Correspondence Between  
Staff and Applicant  
Approval Letter

RE: 21-ZN-2013  
Cottonwoods Resort Commercial Parcel

The Community & Economic Development Division has completed the review of the above referenced development application submitted on December 16, 2013. The following **1<sup>st</sup> Review Comments** represent the review performed on by our team, and is intended to provide you with guidance for compliance with city codes, policies, and guidelines related to this application.

# EXISTING CONDITIONS MAP FOR COTTONWOODS MIXED USE PROJECT

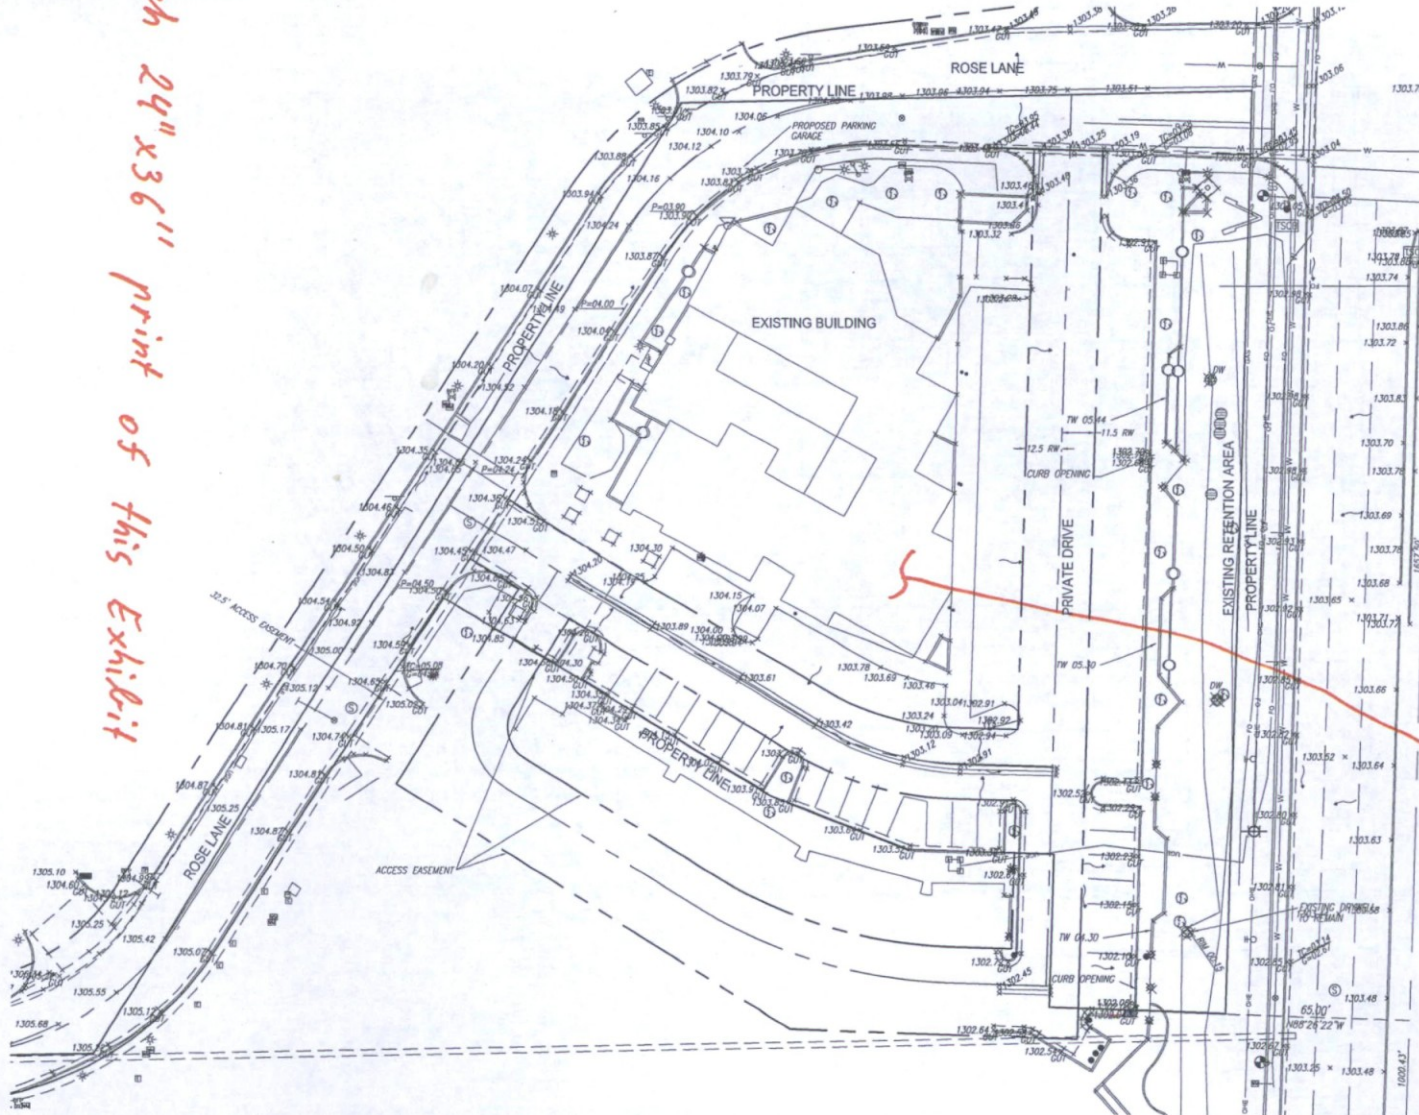
*Show and label  
existing contours*

Attach 24" x 36" print of this Exhibit

DA-3	DRAINAGE AREA ID
DW	DRYWELL
CB#1	CATCH BASIN ID
VR	RETENTION VOLUME REQUIRED
VP	RETENTION VOLUME PROVIDED
SD-1	STORM DRAIN ID
	SURFACE WATER FLOW ARROW
	DRAINAGE AREA BOUNDARY
	PROPOSED CONTOUR
	PRELIMINARY PROPOSED GRADES

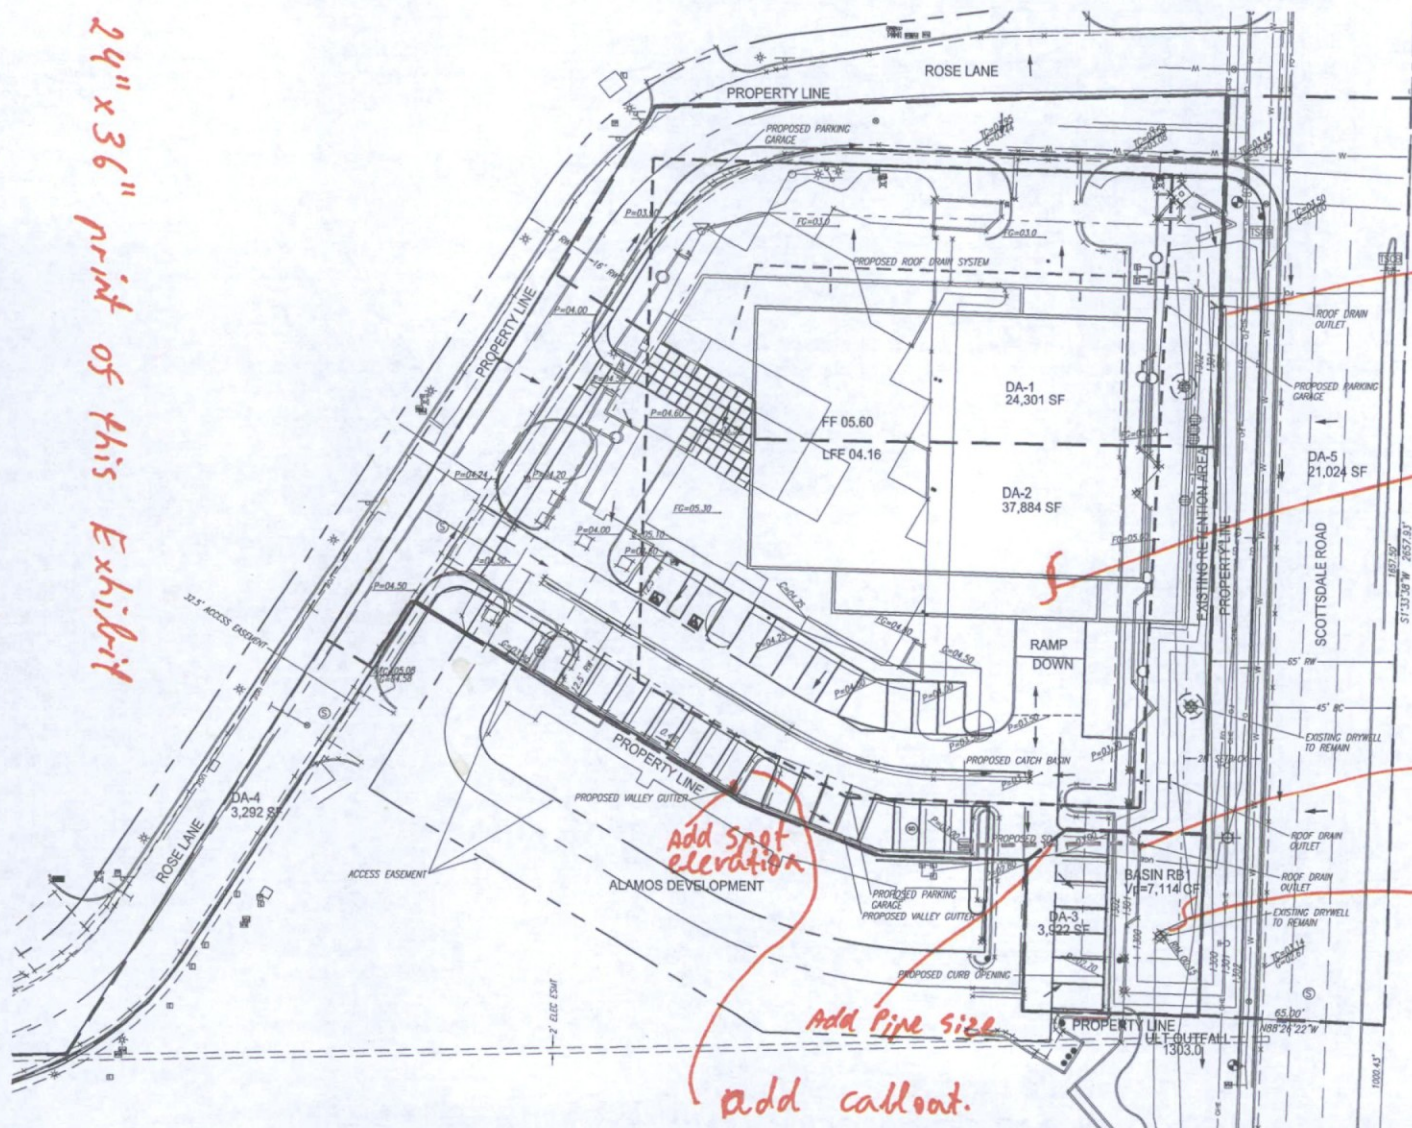
Add  
Invents

- show and label existing contours

Add  
-Inverts

- show and callout  
drainage  
easements.
